Local Traffic Committee Meeting

Venue	Conference Room, Station Street, Mullumbimby
Date	Tuesday, 3 June 2025
Time	9:00 AM

Report No. 6.1 Intersection upgrade at 189 Federal Drive

189 FEDERAL DRIVE, FEDERAL EXTERNAL INTERSECTION DESIGN
GENERAL ARRANGEMENT PLAN WITH AERIAL IMAGE

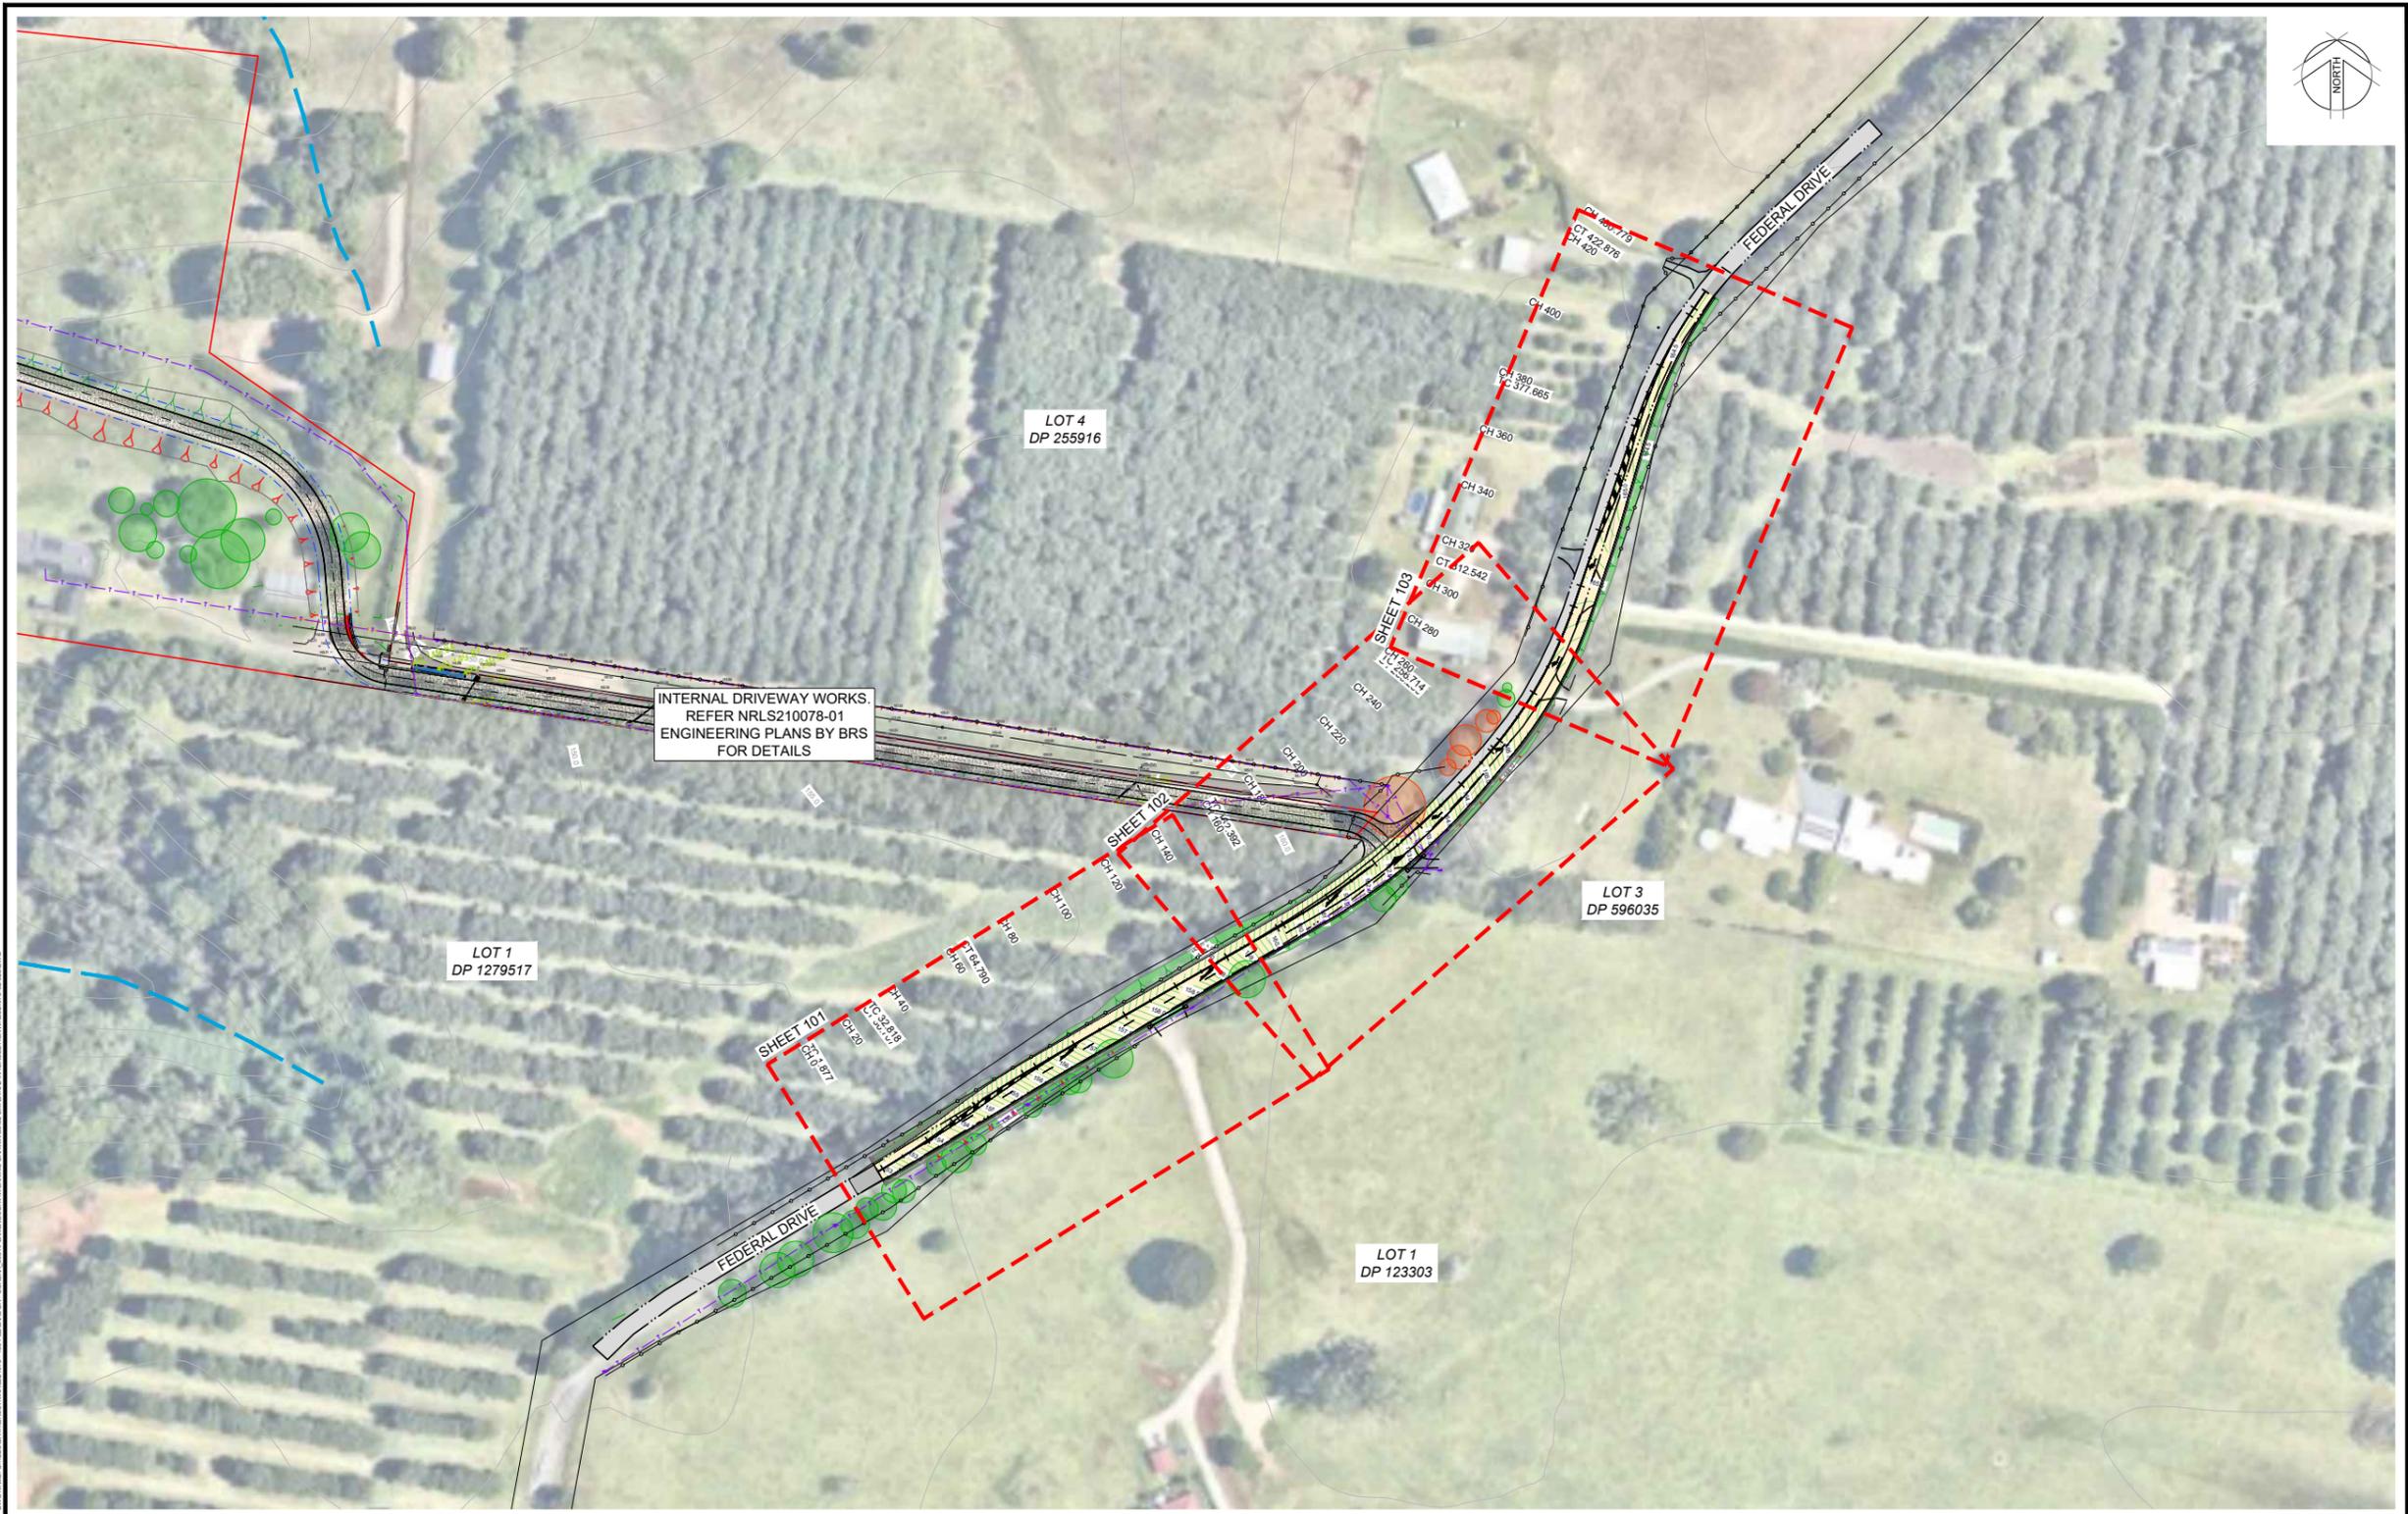
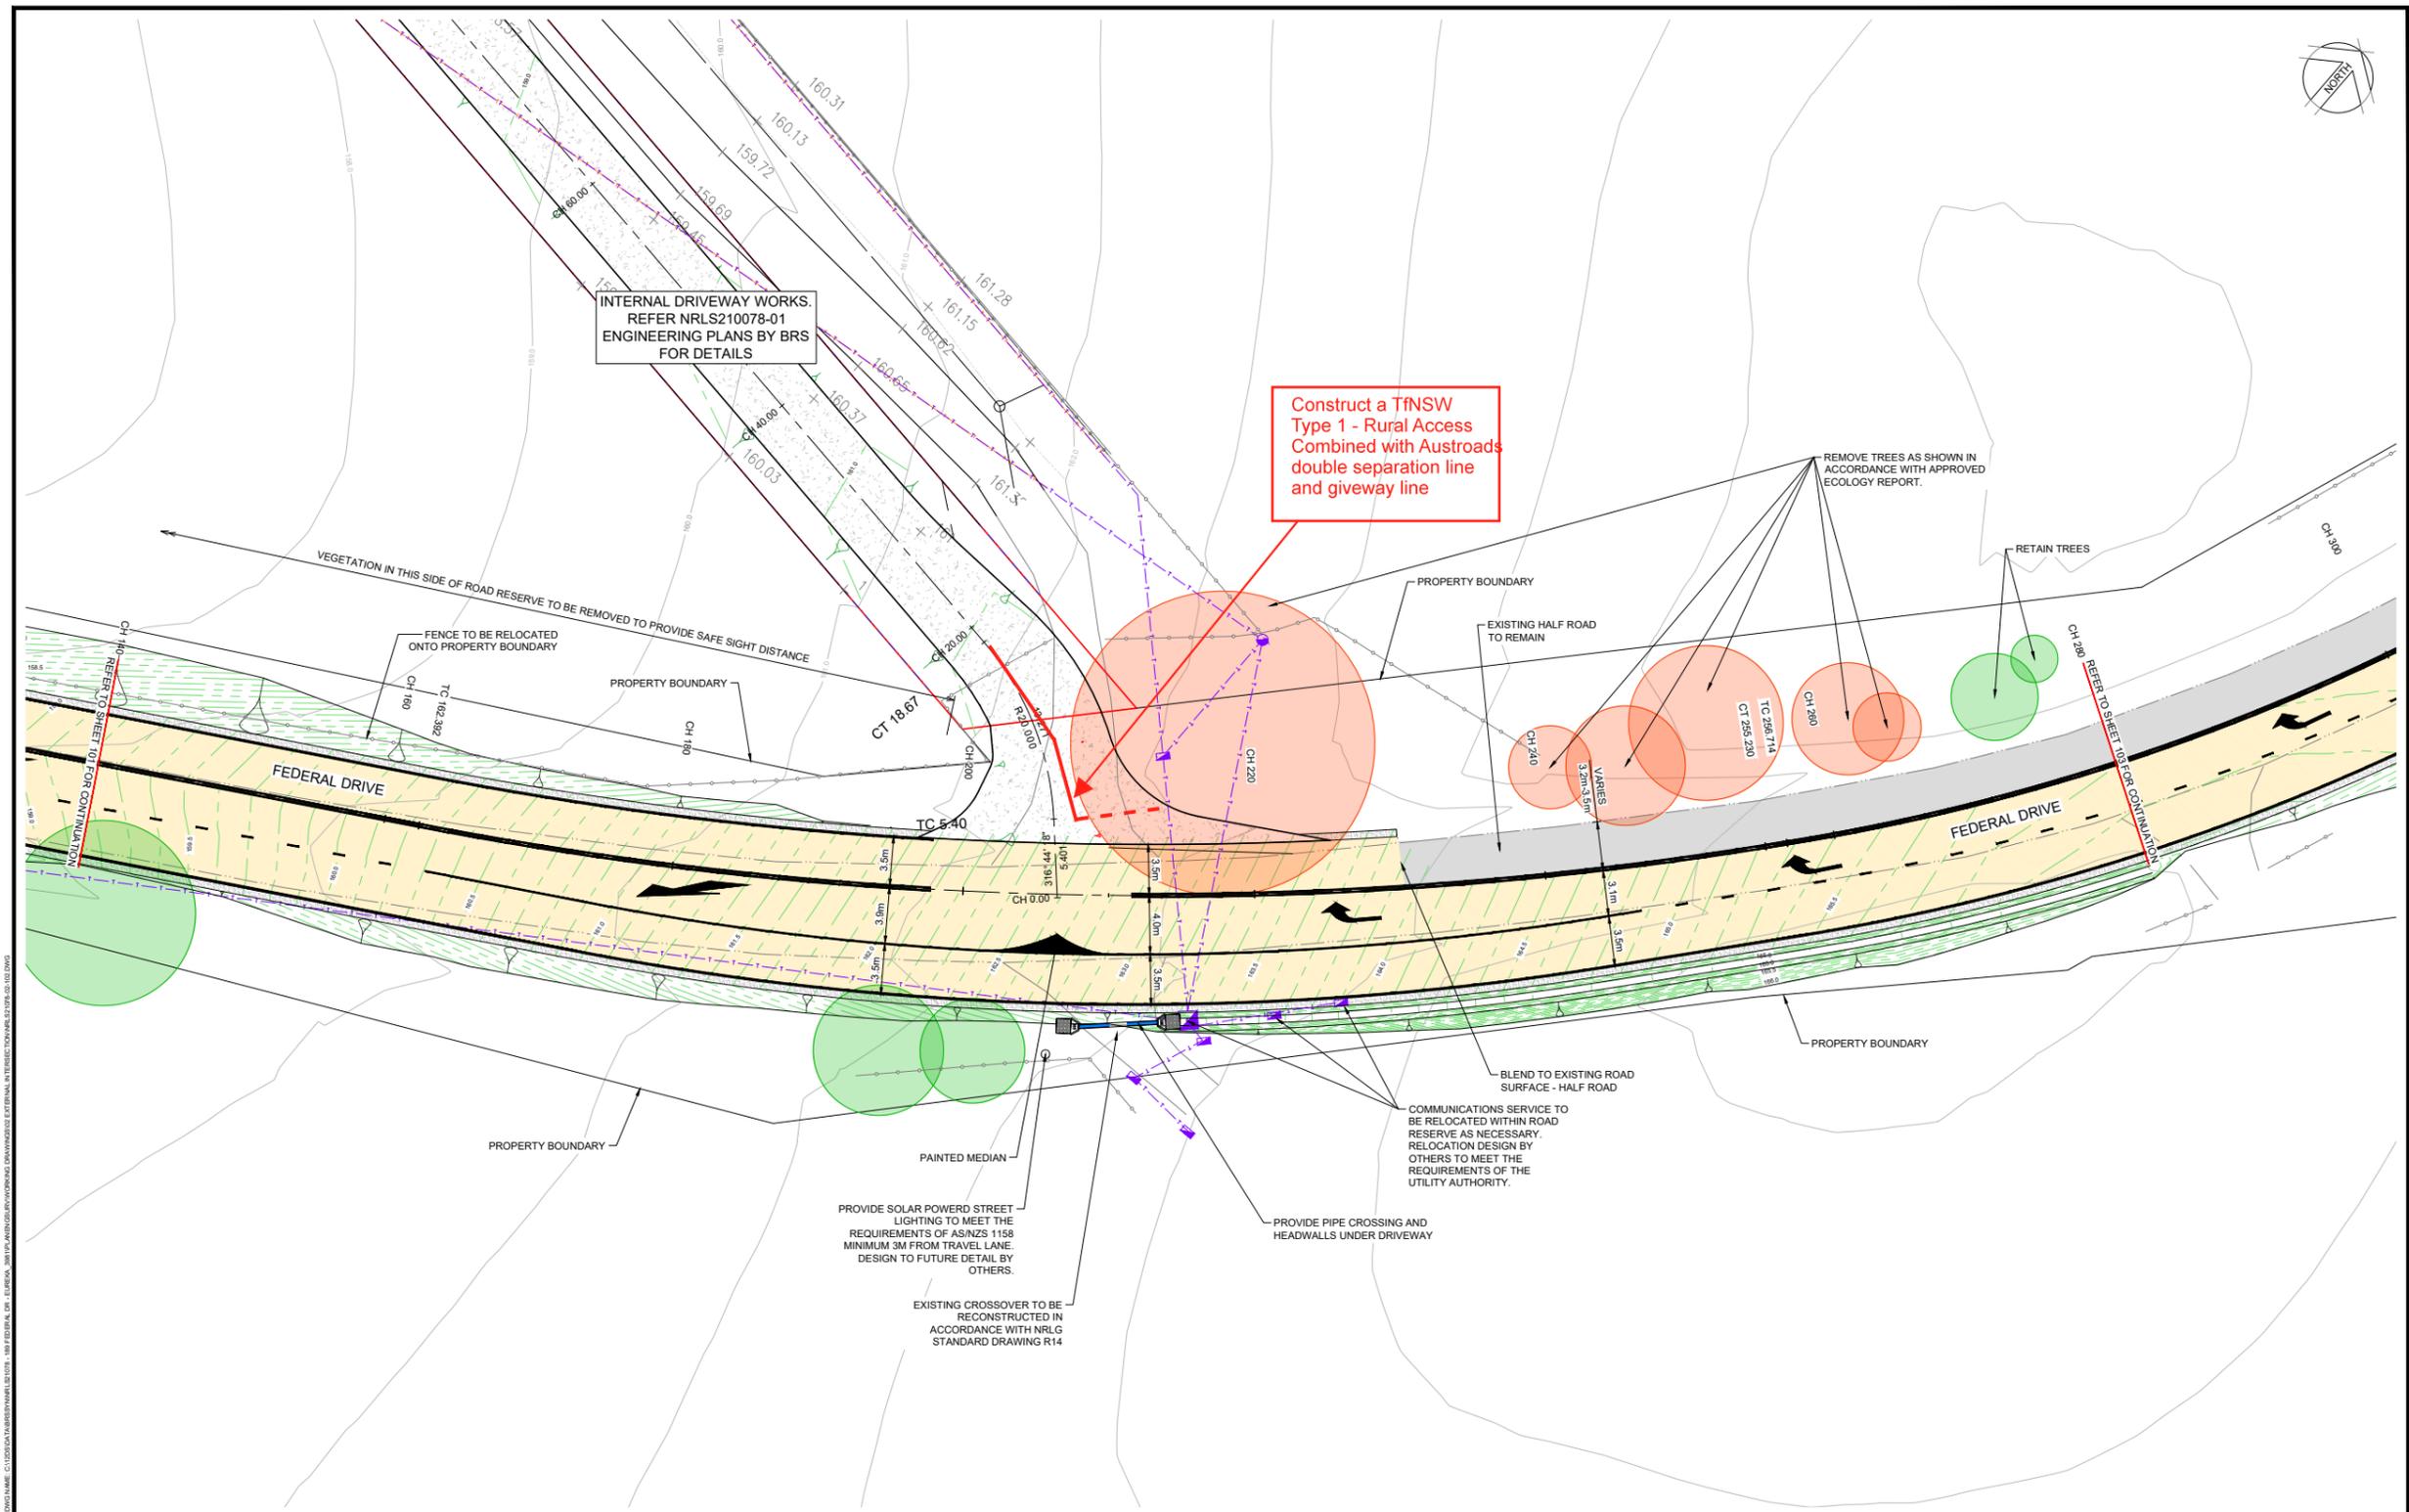
The following changes and requirements must be adopted into the modified seagull intersection design:

- Travel lane at 3.5m.
- Auxiliary lane at 3.0m
- Length of seagull painted island at 70m
- Width of seagull painted island at 3.5m
- Flag lighting in accordance with AS1158
- Acceleration lanes, deceleration lanes, painted medians, right turns, left turns but not limited to in accordance with Austroads Guide to Road Design
- Design speed of 90kph
- The seagull treatment must be supported with a swept path analysis plan to cater for a standard side loading refuse collection vehicle (RCV) specified in Chapter B8 of Council's BDCP coming from all directions. The RCV must enter and exit in forward direction.

Note: the supporting swept path analysis plan did not include maneuvering coming from the north and exiting heading south

That the Local Traffic Committee endorses the proposed intersection plan as nominated in Attachment 1 (E2025/51169).
